# Errata Sheet

**Product Family:** C-more Micro-Graphic Touch Panels

**Manual Number** EA1-MG6-USER-M

**Revision and Date** 1st Ed, Rev E, 07 / 2013

**Page 6-32:**

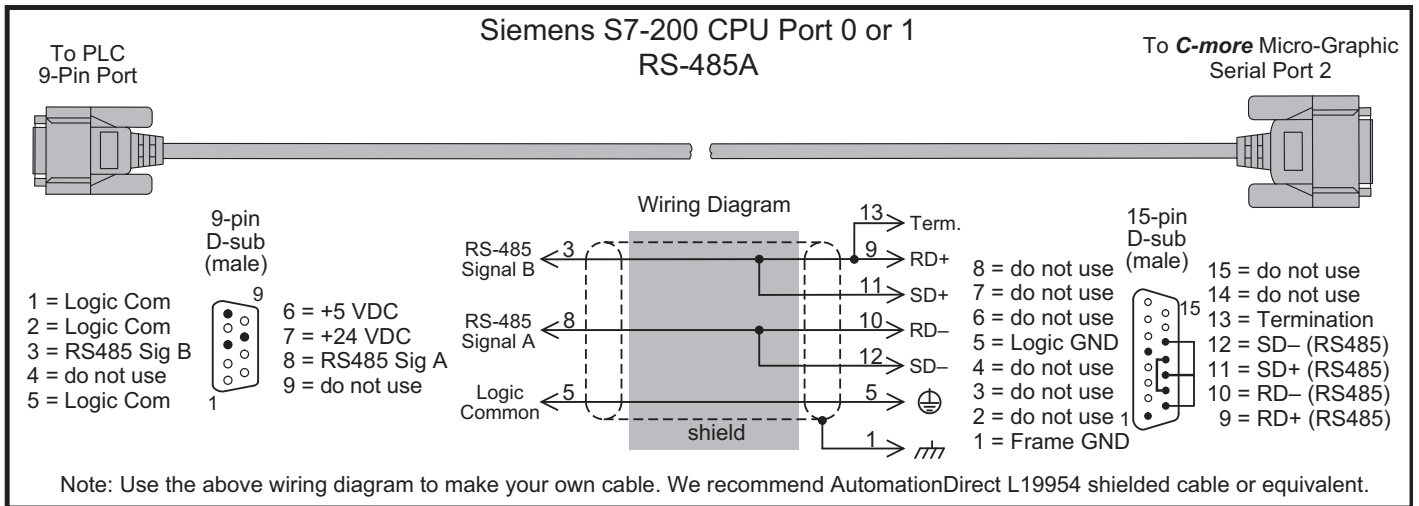
Siemens S7-200 CPU - RS-485 wiring diagram has been corrected.

### Setting – Reset to Factory Default

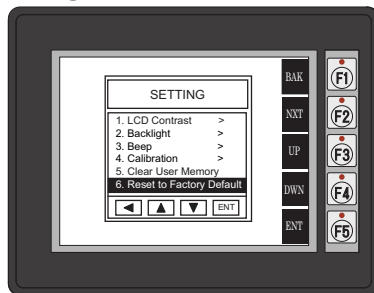
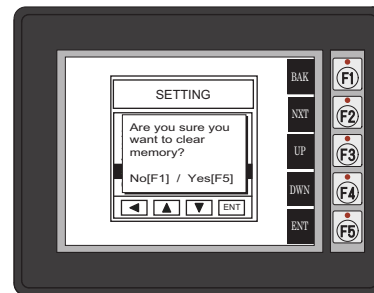
Revised Reset to Factory Default Instructions. Corrected page follows...

With Reset to Factory Default highlighted, press ENT [F5]. Press [F5] to restore all settings to factory defaults and clear user memory. Press [F1] to cancel.

Factory default values can also be reset by pressing F2 and F4 while cycling power to the panel. The Factory Default values are:

- LCD Contrast value of 8
- Green backlight color for EA1-S6ML, white backlight color for EA1-S6MLW
- The internal audible beeper enabled
- Forced touch panel calibration
- User program cleared from memory
- Hourglass icon delay of 350 ms.
- Horizontal orientation
